Mr. Dwight Russell, P.E.
Municipal Solid Waste Permits Section – MC 124
Texas Commission on Environmental Quality
12100 Park 35 Circle; Bldg. F
Austin, Texas 78753

Re: Pescadito Environmental Resource Center - Webb County
Municipal Solid Waste (MSW) Permit Application No. 2374
Notice of Deficiency - Technically Complete Permit Application Supplement Number 5
Tracking No. 21876231; CN603835489/RN106119639

APTIM Environmental and Infrastructure, Inc. is in receipt of your letter dated October 23, 2017 in which you are asking for additional information and clarification related to our submittal of August 17, 2017.

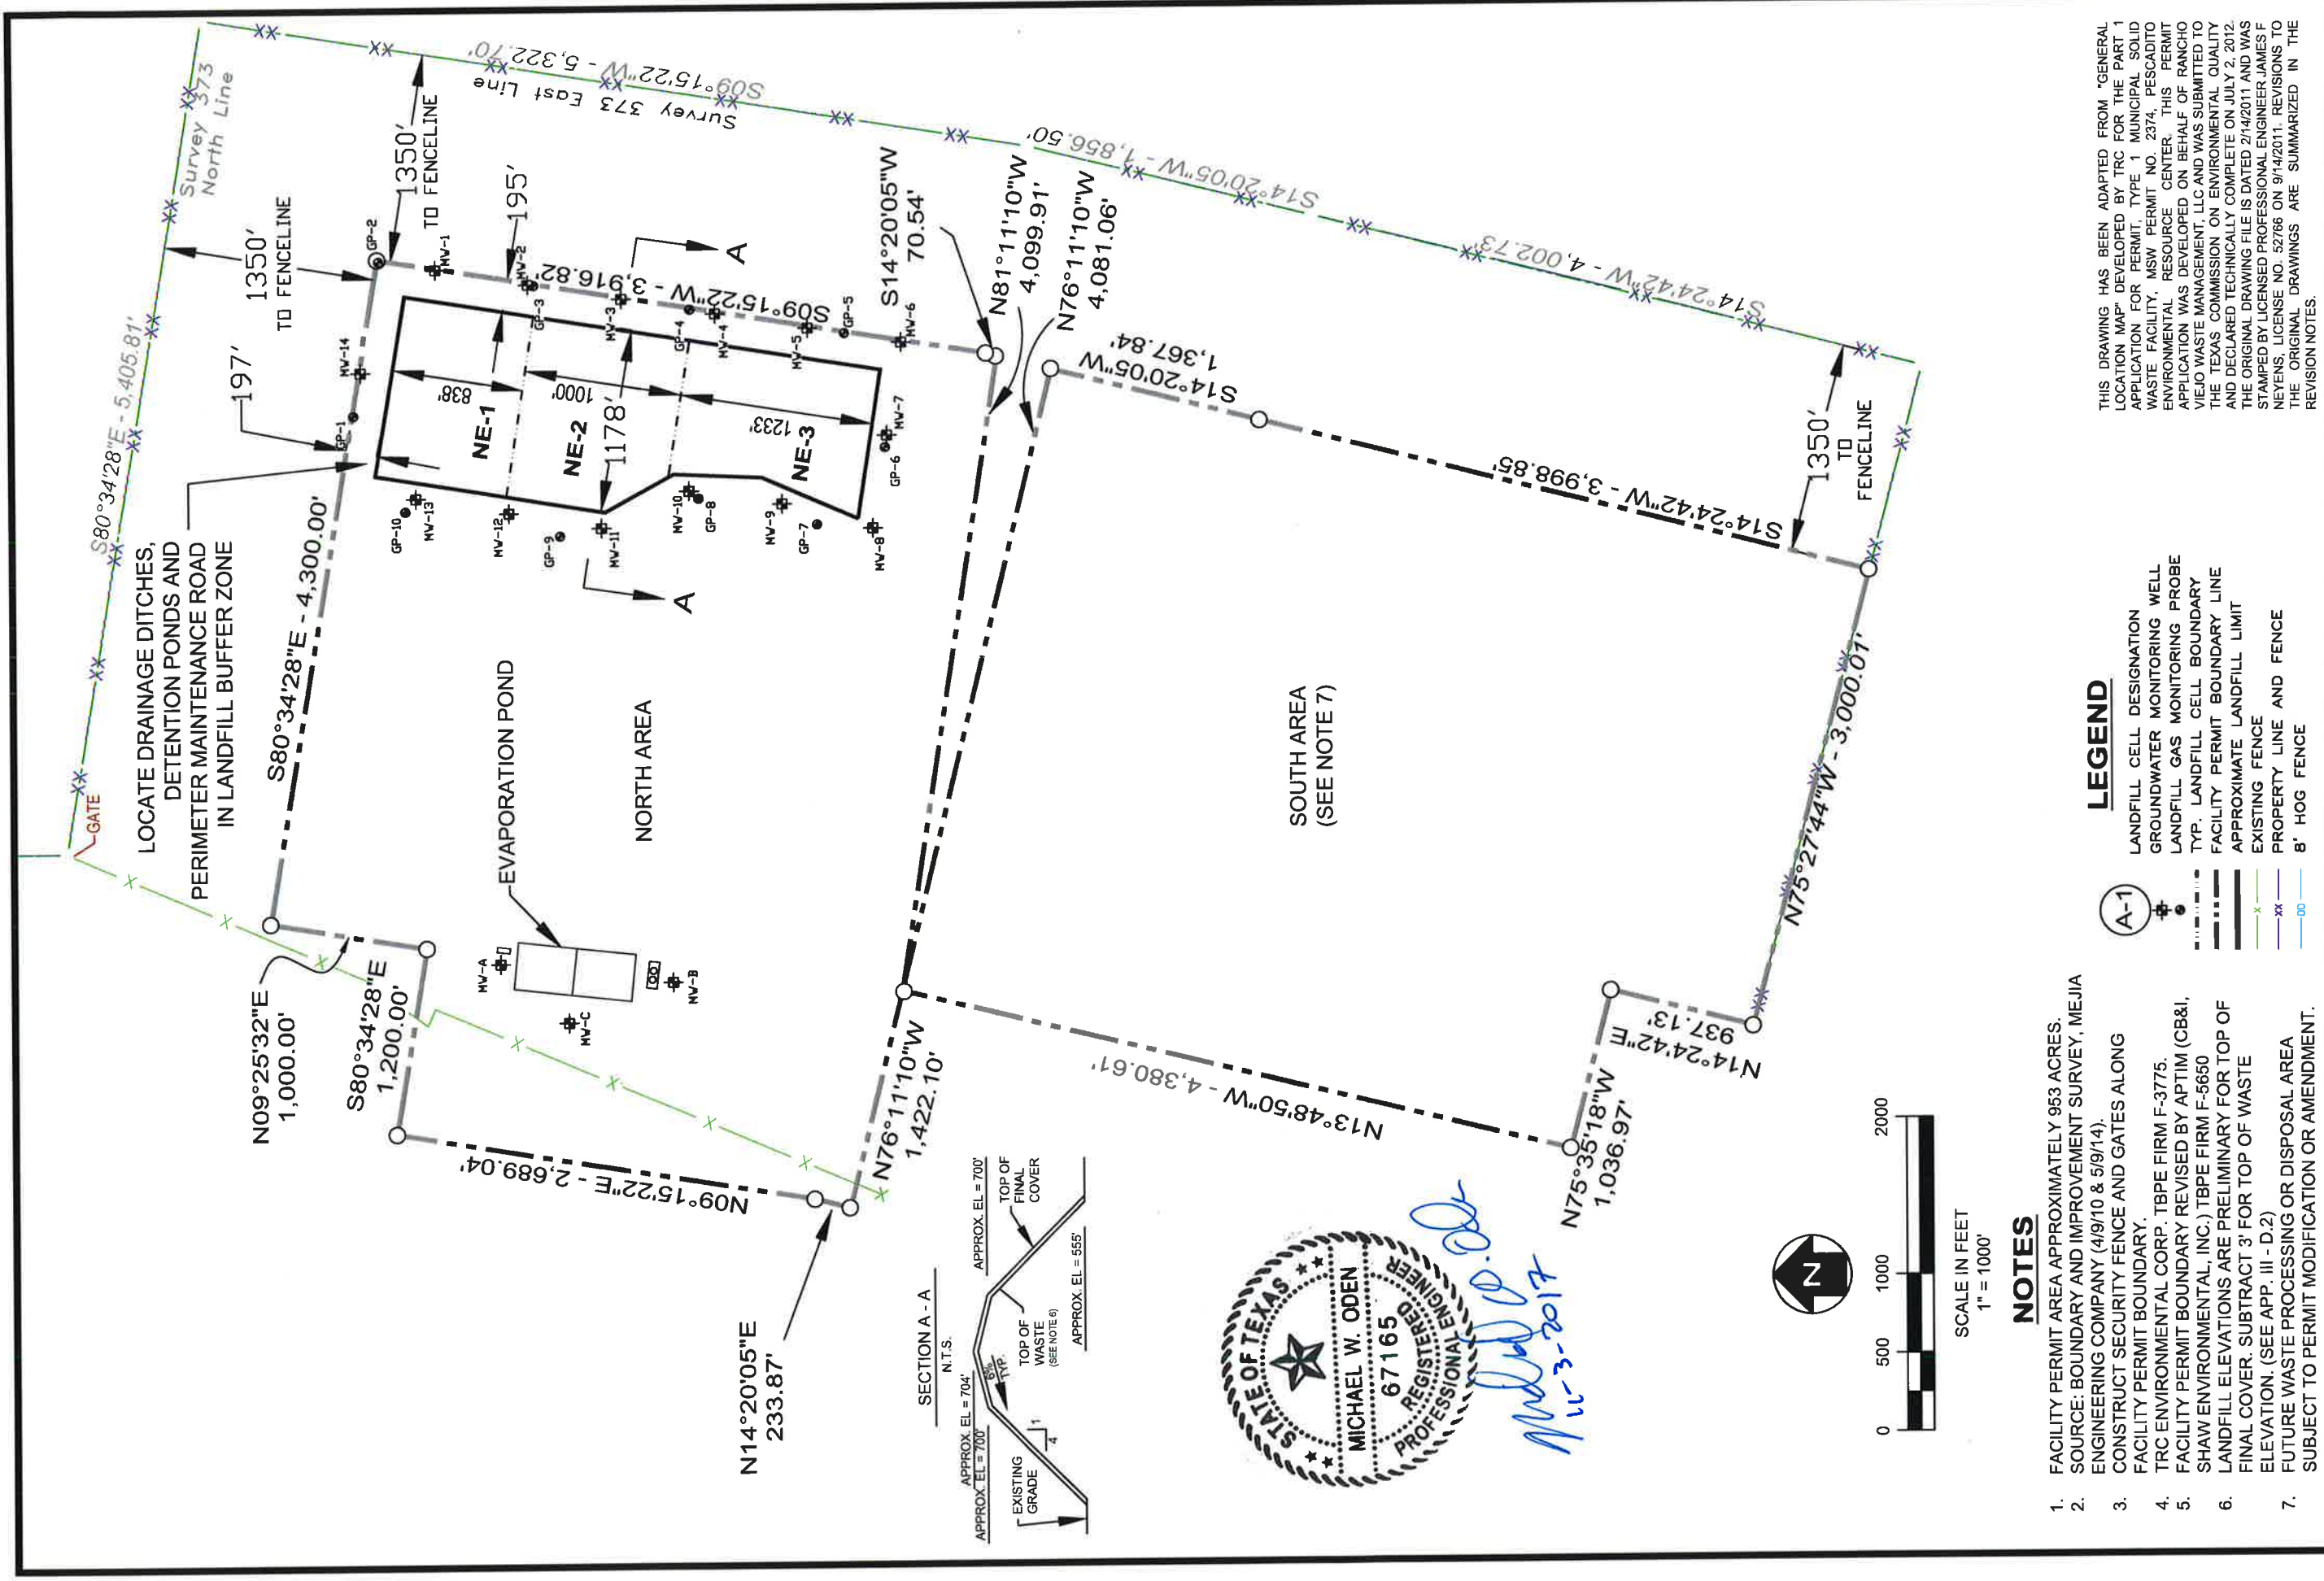
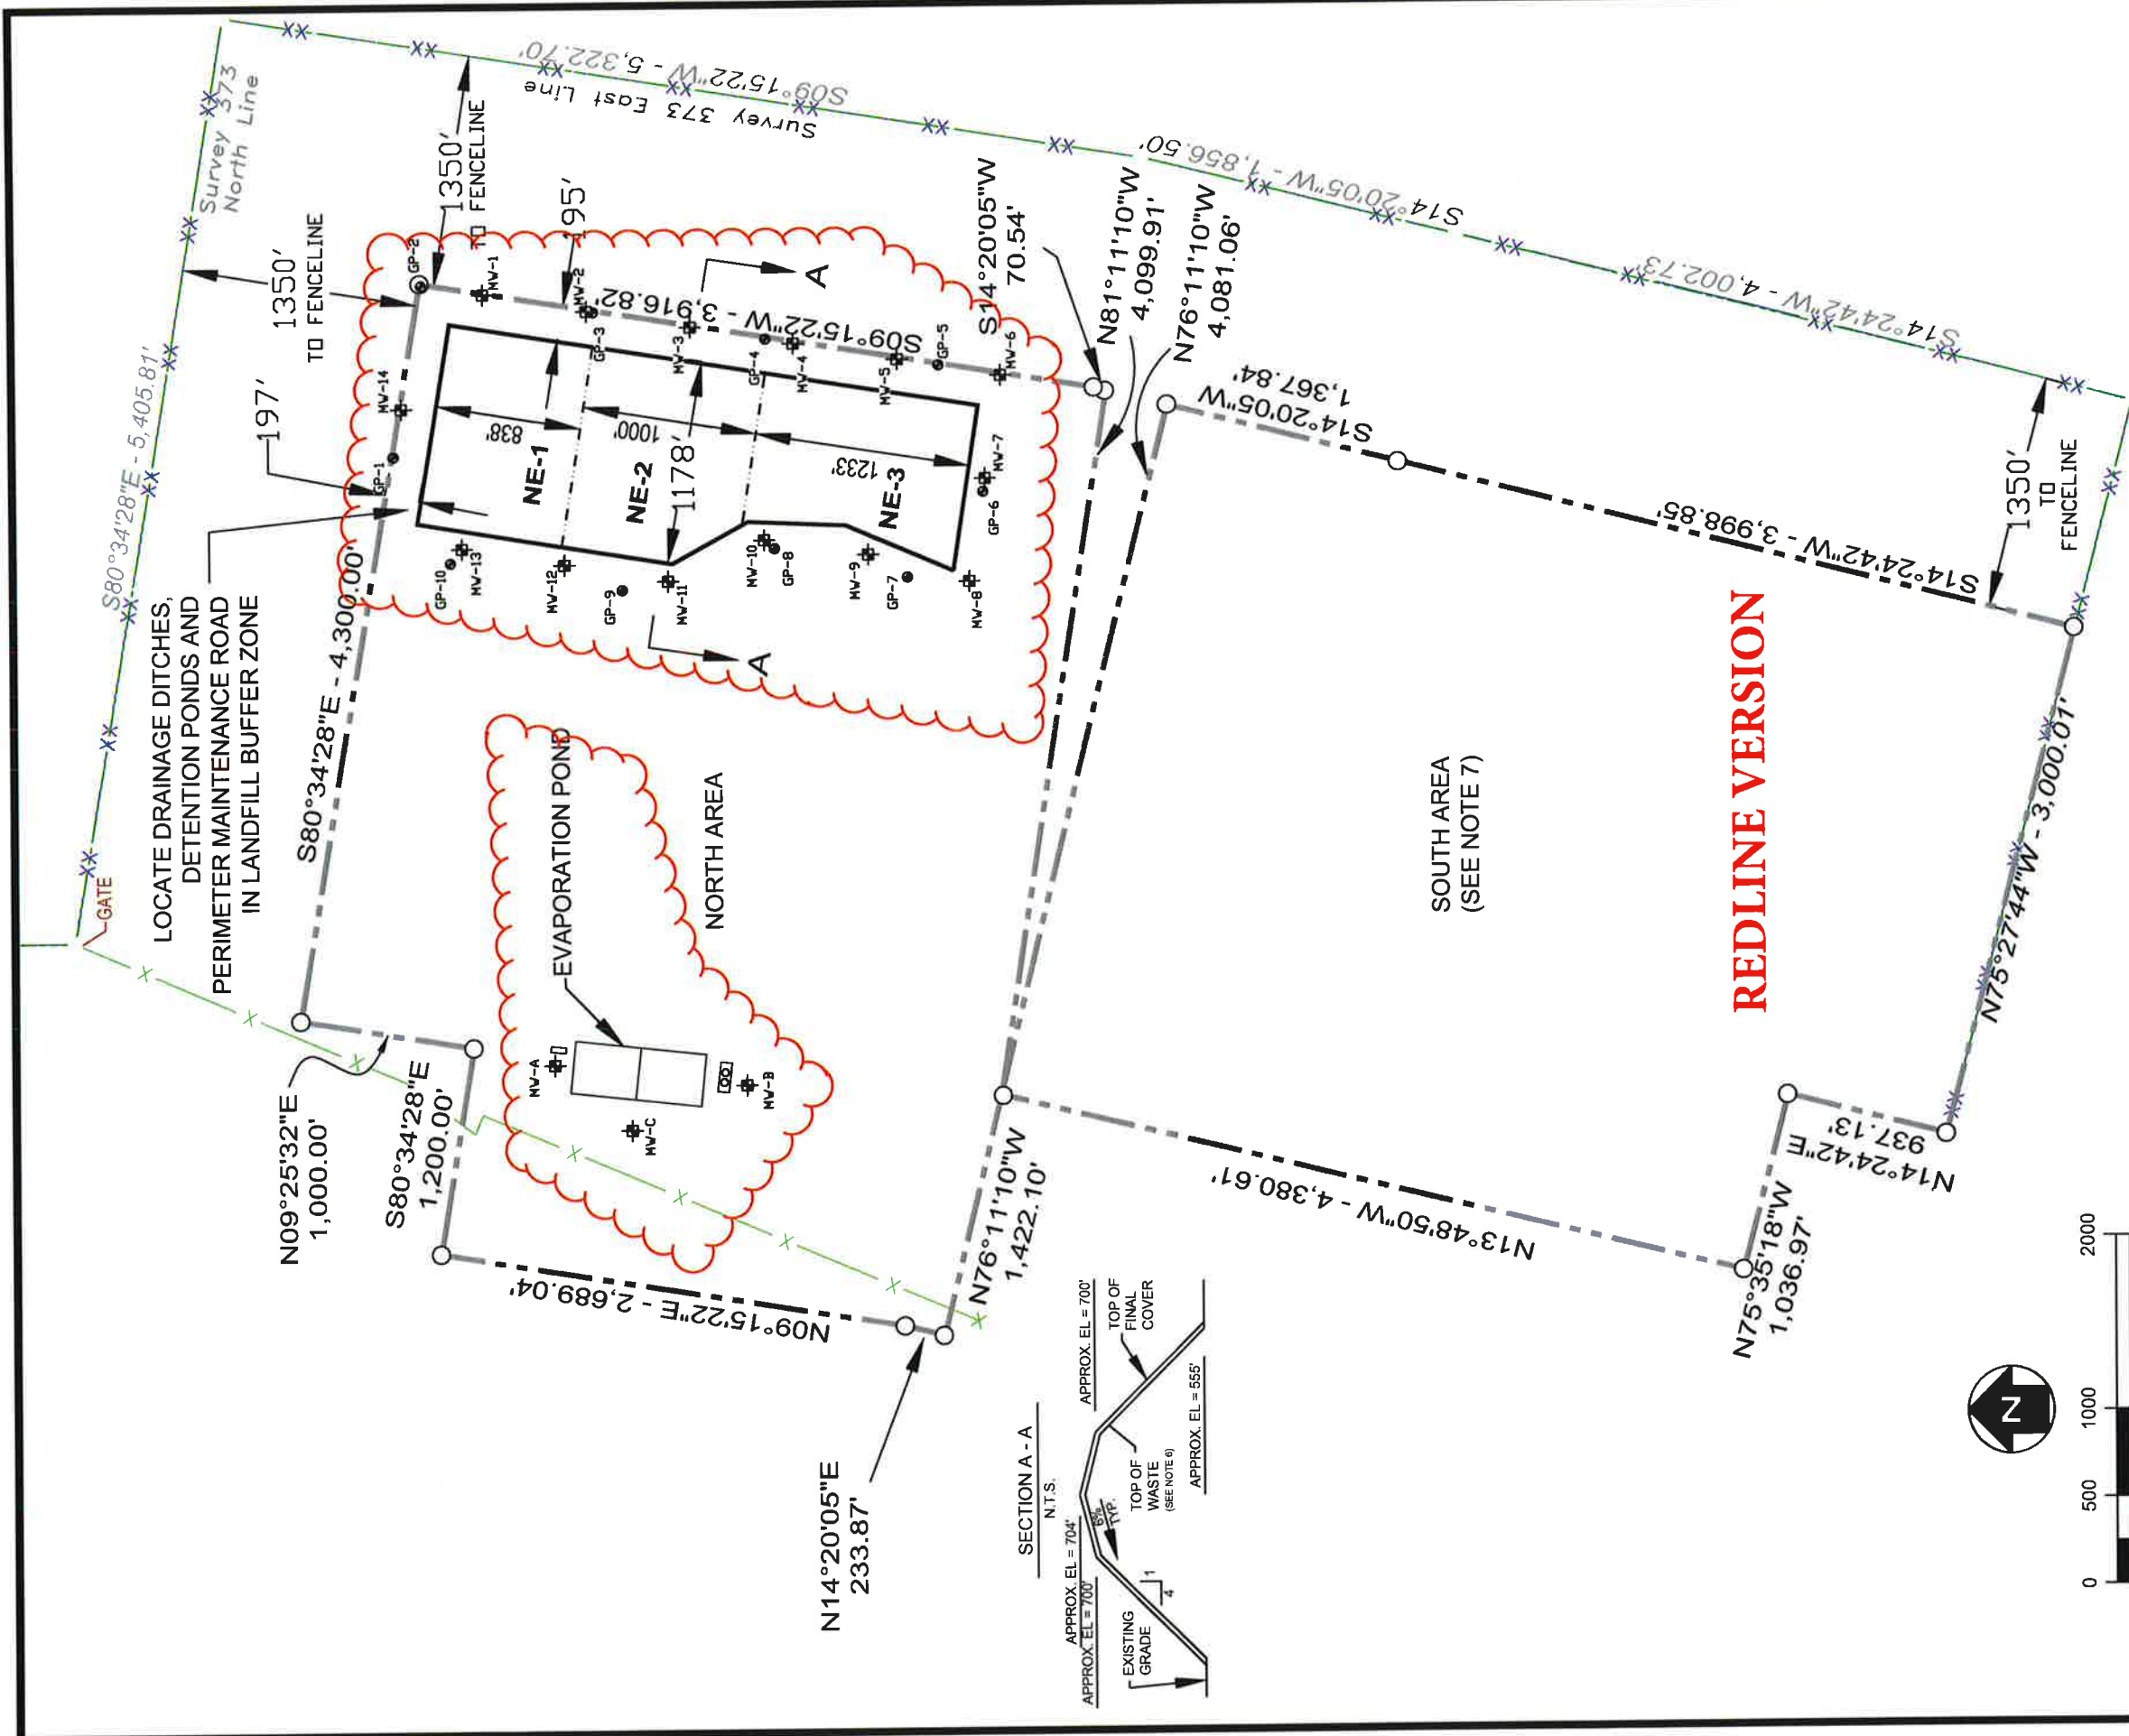
- 3) No groundwater or gas monitoring wells are shown on Figure 5 as described in Part II, Page 17. Please revise.

Figure 5 in Part II has been revised to include the Groundwater Monitoring Wells and Landfill Gas Monitoring probes.
